OUT16/43366

Springvale Colliery Extension Project Modification 1 (SSD 5594 MOD 1) Comment on the Response to Submissions

Springvale Colliery Extension Project Modification 1 (SSD 5594 MOD 1) Comment on the Response to Submissions Detailed comments – DPI Water

Figure 1. Extracted Figure 2.1 from Jacobs' report

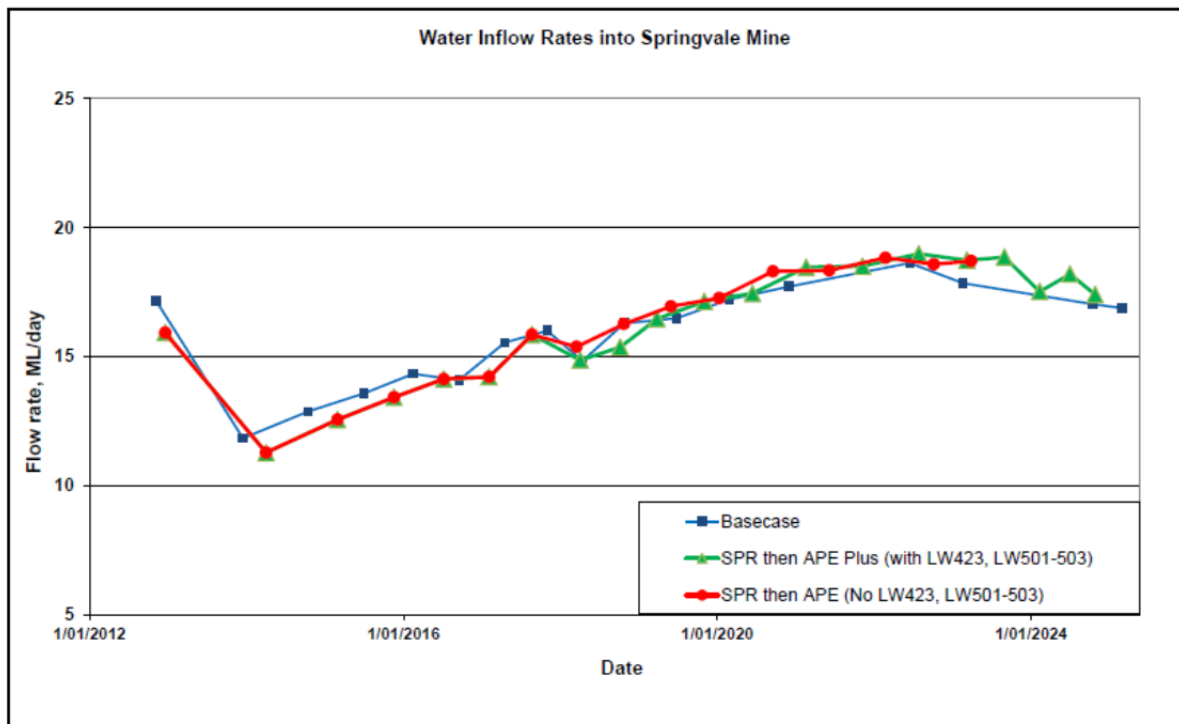
The Proponent has re-run their COSFLOW NGM for the correct mine layout and generated the necessary outputs. The outputted results now properly reflect the approved mine layout, irrespective of any business reason to exclude them (see Appendix C for an enhanced discussion). The previous work was erroneous and poorly explained. The revised outputs are shown in Figure 1 and are very similar to the original. Following this, the Proponent's analysis of the results depicted in Figure 1 is presented.

Key aspects are provided as follows:

- The mine inflow results presented for the 'SPR then APE Plus' simulation, which included all approved longwalls at Springvale Mine under SSD5594, are consistent with the original 'SPR then APE' case (Adhikary and Wilkins, 2015) and the CSIRO (2013) predictions (Adhikary and Wilkins, 2013) which assessed the entire mine footprint. Maximum mine inflows for the three simulations are provided below:
 - The maximum mine inflows for the 'Basecase' (Adhikary and Wilkins, 2013) is 18.6 ML/day in 2022
 - The maximum mine inflows for the 'SPR then APE' case (Adhikary and Wilkins, 2015) is 18.8 ML/day in 2022
 - The maximum mine inflows for the 'SPR then APE Plus' case (Adhikary, 2016) is 19.0 ML/day in 2022.
- The Springvale Mine Extension Project EIS (Section 10.2.3.1) notes the maximum mine inflow for the whole mine plan, the 'Basecase', as approved, as 19 ML/day in Year 2022.

Given the above, the baseflow predictions, with respect to modelled surface water reaches, and modelled mine inflows in the 'SPR then APE Plus' simulation, are consistent with Adhikary and Wilkins (2015) report, and, as presented in Adhikary and Wilkins (2015), are consistent with Adhikary and Wilkins (2013). The impacts and environmental consequences for the proposed modification area are therefore expected to be consistent, as discussed in the SEE, with the impacts presented in the SVMPE EIS and approved in SSD5594.

DPI Water accepts this analysis.
